# Product Change Notification (PCN)

| PCN Number                              | 508585  | Date Issued | March 26, 2020 |
| Reason for Change                       | Change to Product   |             |                |

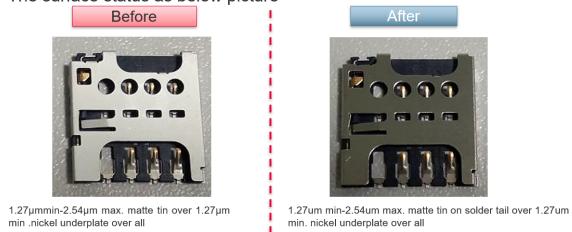
- 78727xxxx series product metal shell surface plating change from matt tin to nickel, the soldering tail plating still is matt tin, it's not effect to soldering. The surface status as below picture

- Due to internal quality improvement of the products for continuous quality enhancement activities, 78727xxxx series product metal shell surface plating change from matt tin to nickel.
- Product Impact  
It has no impact to fit, and function
- Part Number Impact  
787270001  
787273001  
787272001
- Qualification Reports and samples available upon request after the date shown above
